## ADDENDUM

No. 01 Date: 8/29/2024  
Project No. 0020711.01 Attention: Leonard D'Souza  
Project Name: Princess Margaret Cancer Centre  
Stem Cell Transplant 2, MHC, MHDU, DSC  
Address: University Health Network  
610 University Avenue  
Toronto ON

*This Addendum forms a part of the Bidding and Contract Documents and modifies the original issued Bidding Documents (dated August 13, 2024) for the above titled project, as indicated below, and is hereby incorporated into the Contract Documents as part thereof.*

**DEMOLITION PLAN -  
LEVEL 02 (MHC)**

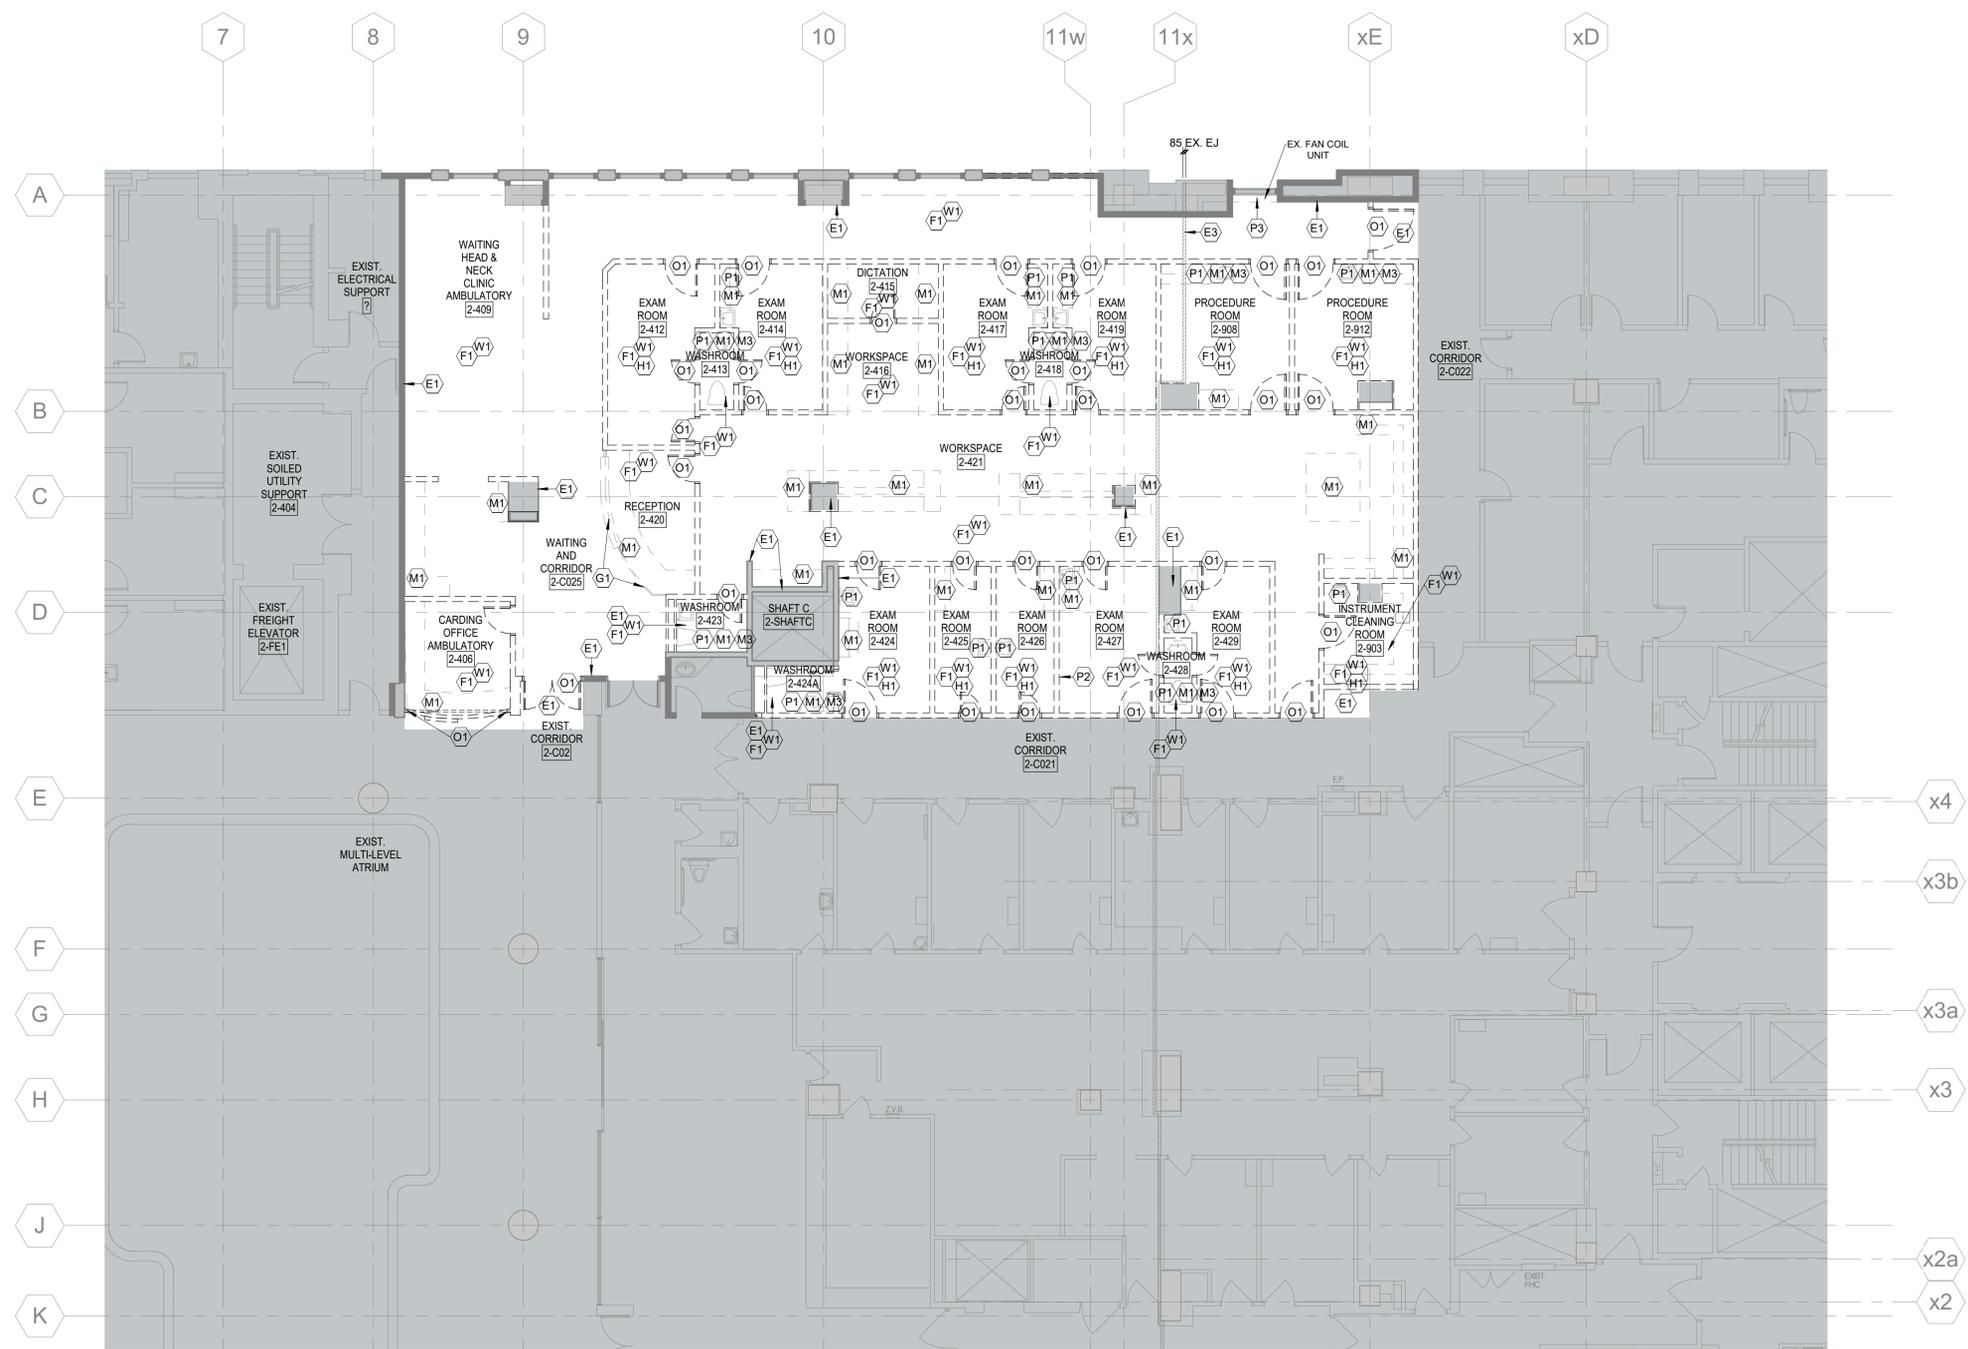
**2. DRAWING D0102 - DEMOLITION PLAN – LEVEL 2 (MHC)**

Added M3 note in the legend.

**DEMOLITION PLAN -  
LEVEL 10 (DSC)**

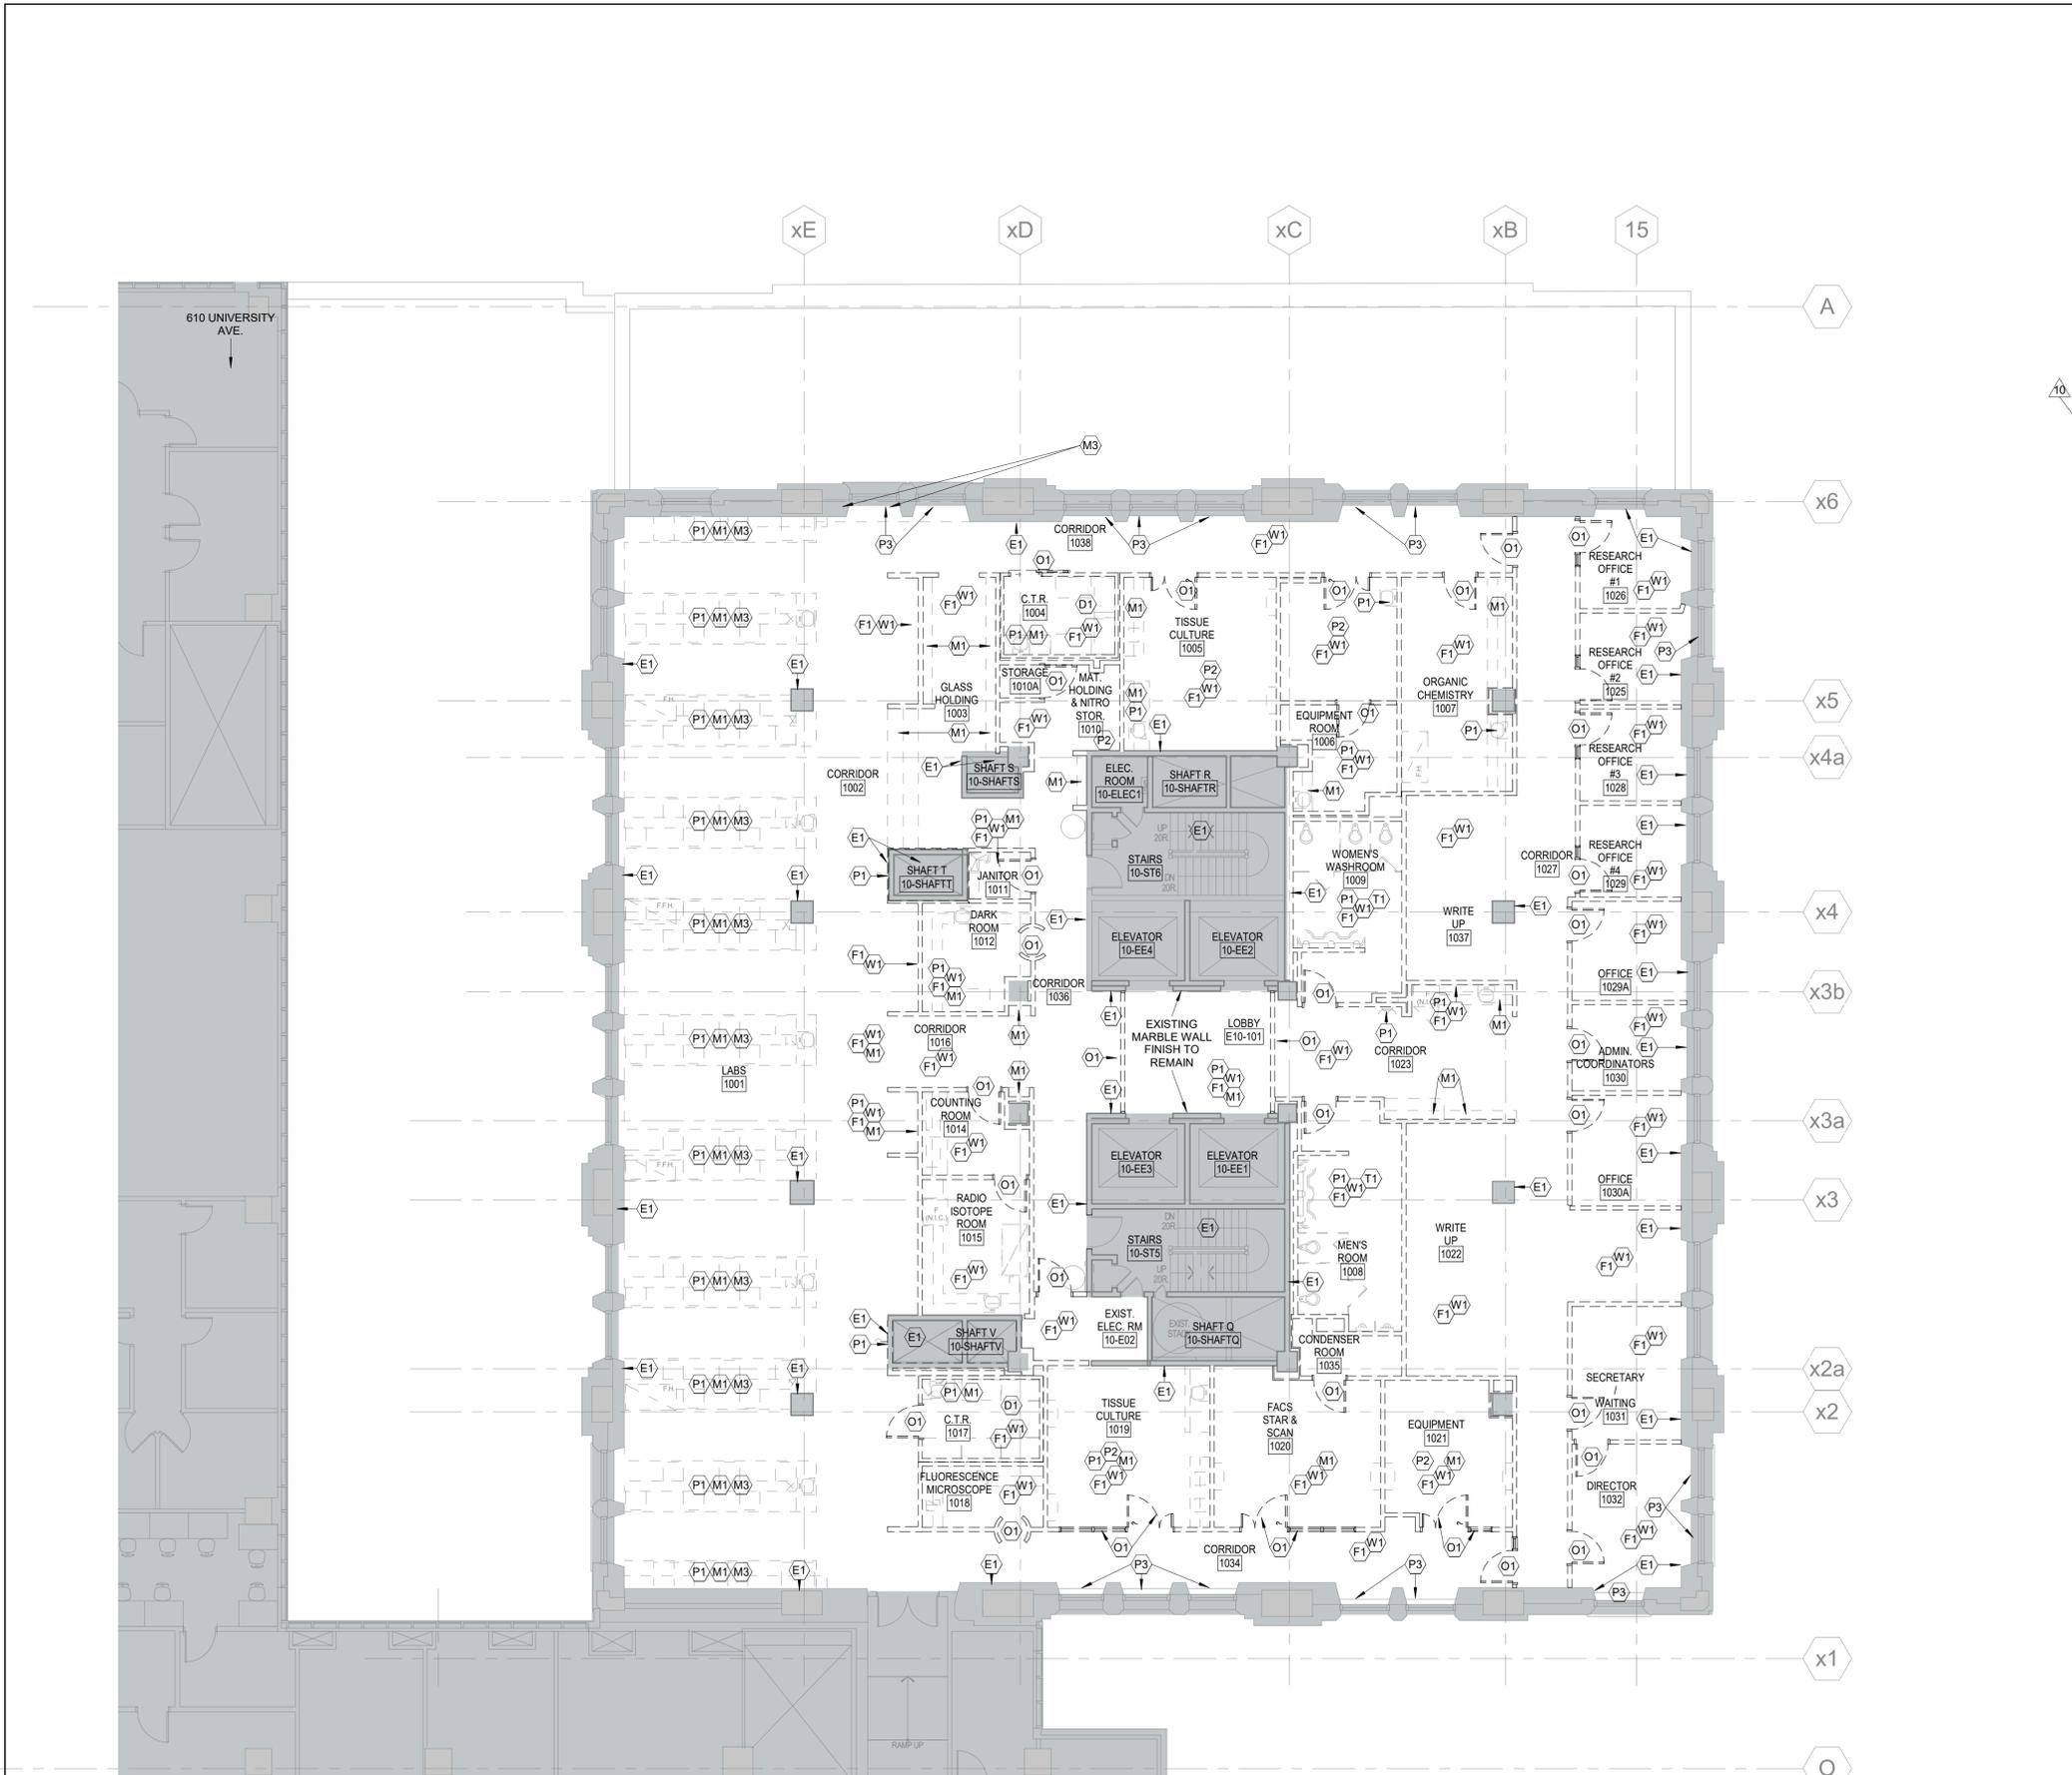
36. Please provide details of legend/notation M3 shown on Dwg. D0110A.

**1. DRAWING D0110A - DEMOLITION PLAN – LEVEL 10 (DSC)**

**Response: Refer to updated D0110A showing M3 note attached within.**

Added M3 note in the legend.

**SP-29 – BUILDING SECTION**

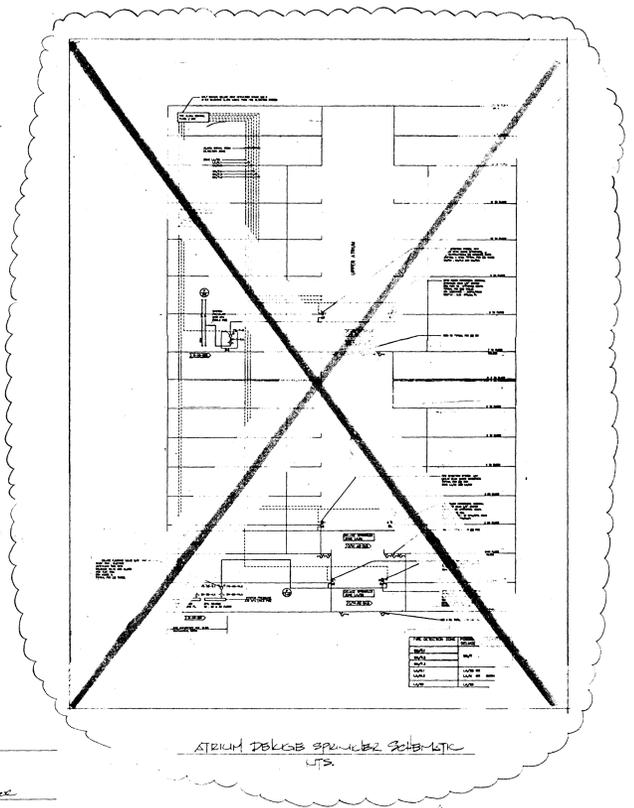
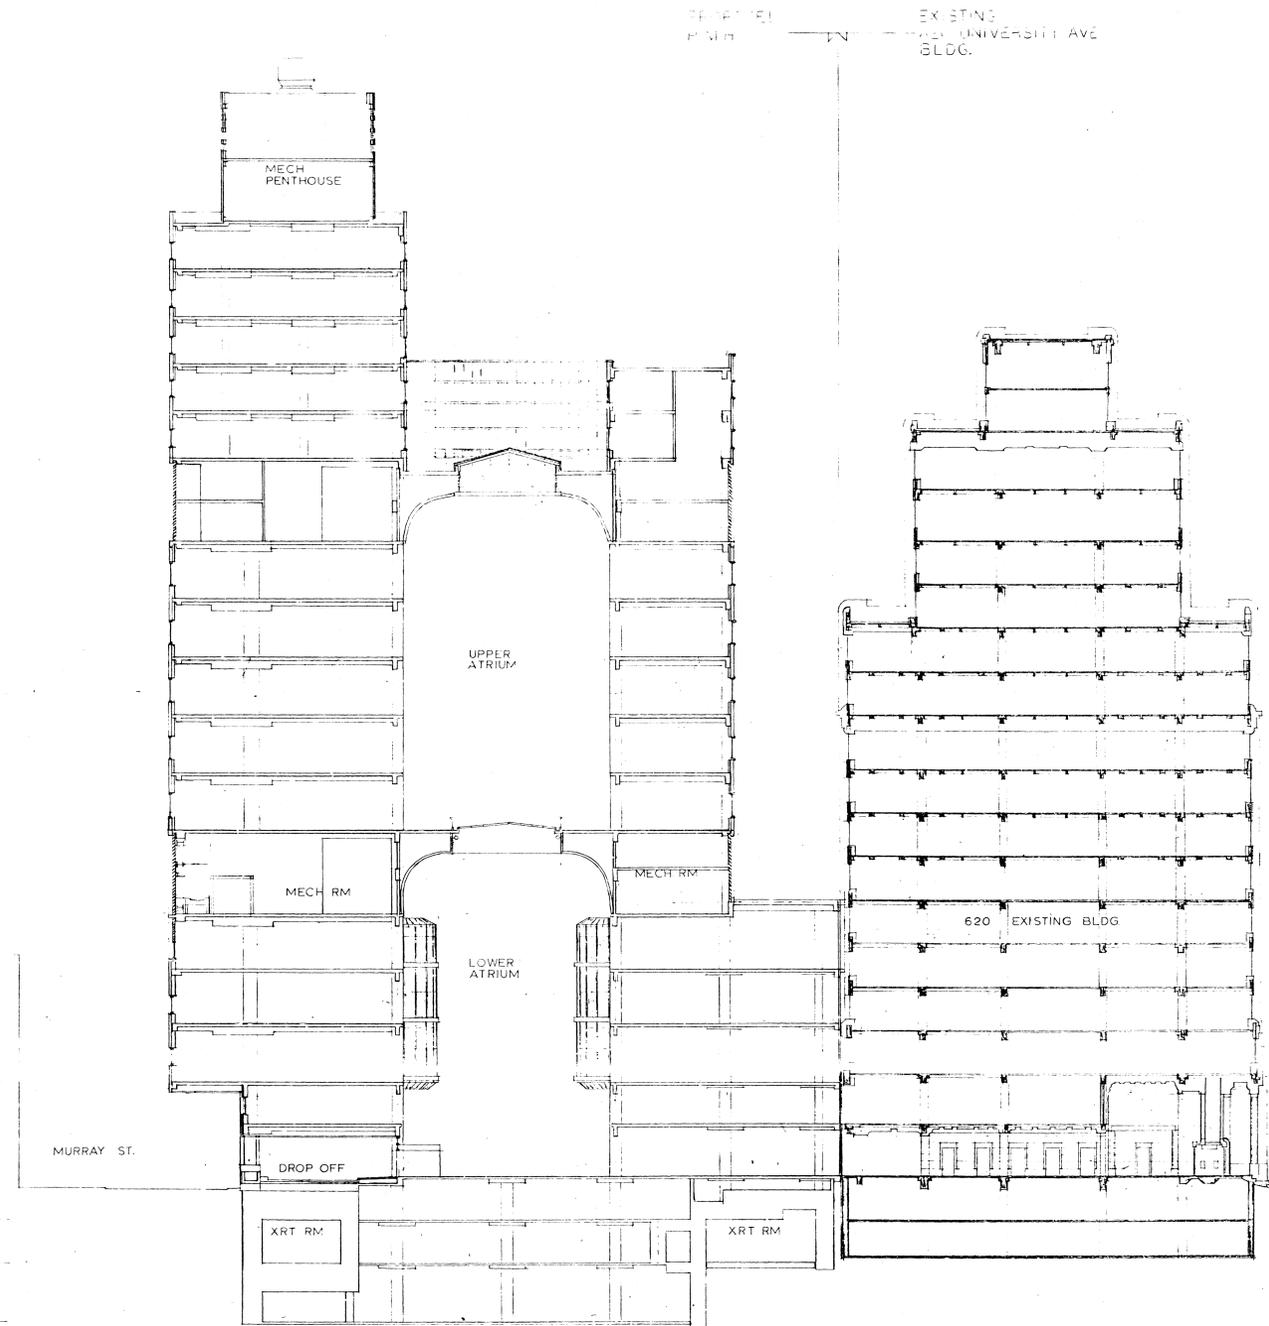
21. Can you clarify the deck height for levels 2 and 10?

29. There are some exposed ceilings on Level 2, Level 5 and Level 10. Please advise the ceiling heights.

**Response: Refer to as-bult drawing SP-29 - Building Section attached within.**

**Response: Refer to as-bult drawing SP-29 - Building Section attached within.**
